OFFICIAL STAR CLASS MEASUREMENT CERTIFICATE

YACHT NO. 3.490

Report from International Measurement Committee

Star No. 3490

STATIONS	HEIGHTS									
	1	2	3	4	5	6	7	8	9	10
CONTOUR	486	353	240.5	157	108	95.2	129	120	279	391
CHINE			302			226		307		451
SIDE *	374		515			532		438		289

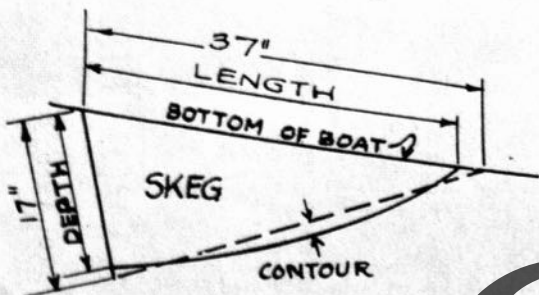
Impossible

*Keel custom station & listed at 120
This is impossible! -*

The Reel contour N° 5 is indicated as 120 - it is a pen
mistake and must be read 190.
